#7874 Millie's Subdivision
Extension request for legal documents & endorse plans

RE: UPDATED Engineering Review of the proposed “**Millie’s Subdivision**”

DEFINITIVE SUBDIVISION PLAN SET OF "MILLIE'S SUBDIVISION" IN NANTUCKET, MASSACHUSETTS

MILLIE'S SUBDIVISION PLANNING BOARD FILE #7874

MILLIE WAY
PLAN, PROFILE & UTILITIES PLAN
OF
"MILLIE'S SUBDIVISION"
DEFINITIVE SUBDIVISION OF LAND
IN
NANTUCKET, MA

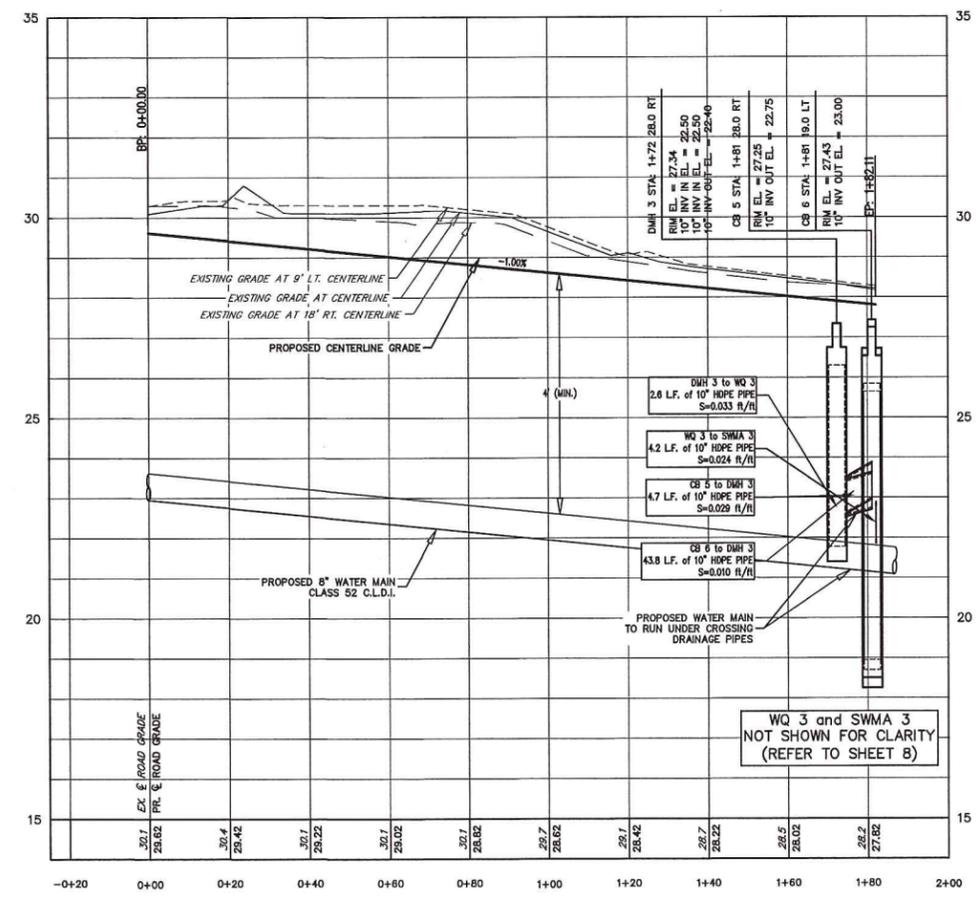
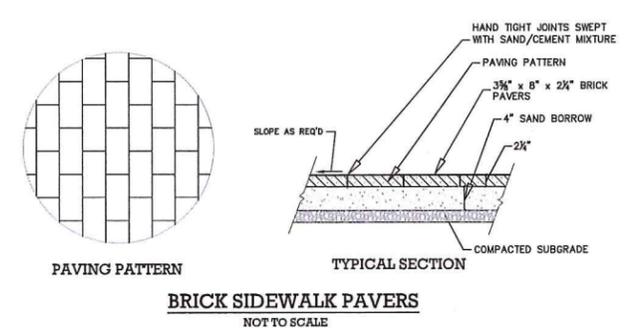
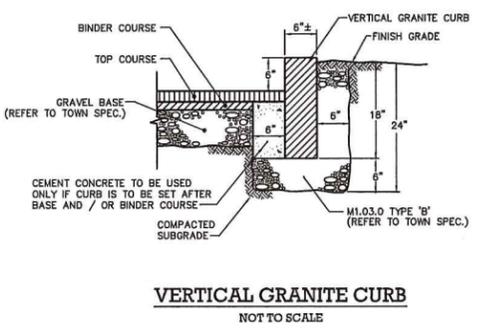
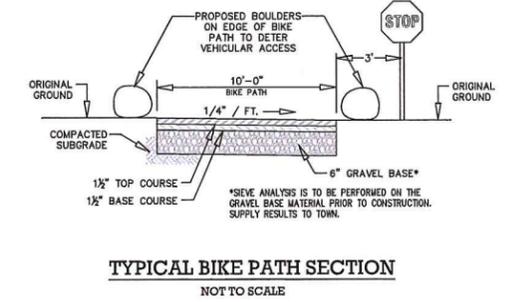
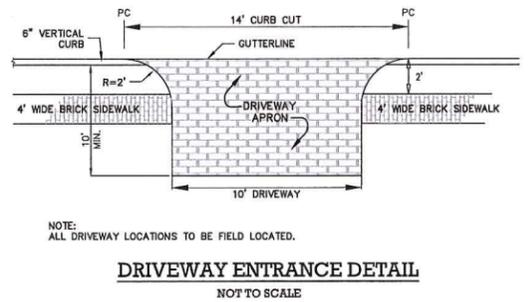
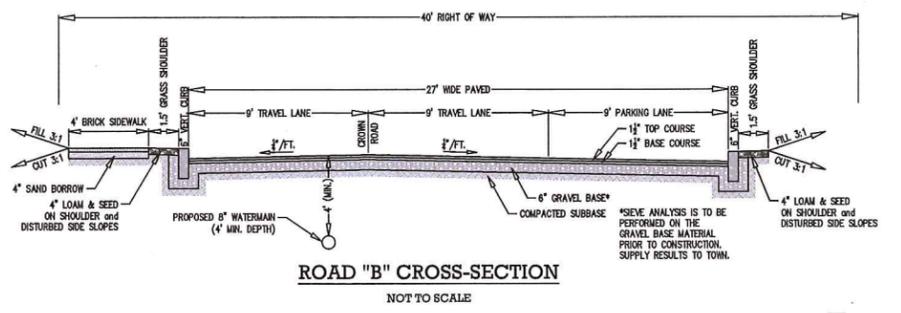
- 2. However we note that the proposed design dimensions of the dead-end turning “tees” do not fully comply with the dimensional requirements of the design shown on Plate No. 4 of the Subdivision Rules and Regulations (SR&R). This should be added to the list of waivers requested for consideration by the Board. Note: The proposed dimensions of 20’ X 49’ X 10’ radii (vs. 30’ X 50’ X 15’ radii in the SR&R) appear to provide adequate access for this subdivision. **Approved by the Board?***

1. We recommend that the Nantucket Fire Dept. review these plans and provide comment to the Board on the adequacy of access and turnarounds for emergency vehicles. **Recived?**

4. We recommend that labels be added to the plans showing the required 25 ft. radii for the curb transition at Bartlett Road. Note: The design currently shows a 15 ft. radius.

6. We note that all but four of the proposed driveways are shown as joint driveways for 2 lots, straddling the affected lots. We recommend that the applicant discuss this with the Board, and decide if separate driveways serving only single lots is more appropriate. **Approved by the Board?**

I will check the dimensions on the turn around, I don't think we asked for a waiver, we should be able to adjust to meet it.

I would rely on the PB staff to see if any comments came in from the FD. If not, I can try to meet with someone over there on Friday.

The shared driveways were discussed with the Board and I believe they are satisfied with the easements we created.
